Access Compliance Report

Public Rights-of-Way

Intersection ID: 31506	Main Street: CHARIDGE_LN	Cross Street: STONEY_CREEK_LN	Location: SE
ADA ID: F10CD07E1EB4	Ramp Type: PerpDiag	Initial Pass/Fail: Fail	Overall Compliance: No
		Severity Score: 30

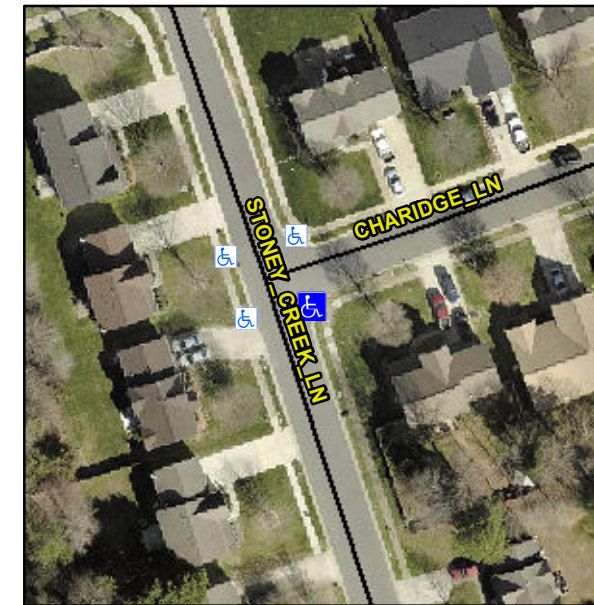
Not Found, R304.5.1, R304.2.2

Compliance	Description	Data	Compliance	Description	Data
N/A	Ramp Length (in)	47.0	No	Ramp Slope (%)	10.5
No	Ramp Width (in)	35.0	Yes	Ramp XSlope (%)	1.3
N/A	Flare Type LT	N/A	N/A	Flare Type RT	N/A
N/A	Flare Slope LT (%)	N/A	N/A	Flare Slope RT (%)	N/A
N/A	Flare Traversable LT?	N/A	N/A	Flare Traversable RT?	N/A
N/A	Landing Length (in)	N/A	N/A	DWS Provided?	N/A
N/A	Landing Width (in)	N/A	N/A	DWS Contrast?	N/A
N/A	Landing Slope (%)	N/A	N/A	DWS Length (in)	N/A
N/A	Landing X Slope (%)	N/A	N/A	DWS Full Width?	N/A
N/A	Landing Curb? (Y/N)	N/A	N/A	DWS Offset (in)	N/A
N/A	Shared Landing?	N/A			
N/A	Gutter Ponding?	N/A	N/A	Gutter Slope (%)	N/A
N/A	Gutter Lip Ht (in)	0.5	N/A	Gutter X Slope (%)	N/A
N/A	Painted X Walk1?	No	N/A	Painted X Walk2?	No
	X Walk 1 Direction	To N		X Walk 2 Direction	To W
N/A	X Walk 1 Width (in)	N/A	N/A	X Walk 2 Width (in)	N/A
	X Walk 1 Slope (%)	3.6		X Walk 2 Slope (%)	3.5
	X Walk 1 X Slope (%)	3.0		X Walk 2 X Slope (%)	2.3

Remove & Replace Curb Ramp With Two New Directional Ramps or Equivalent.
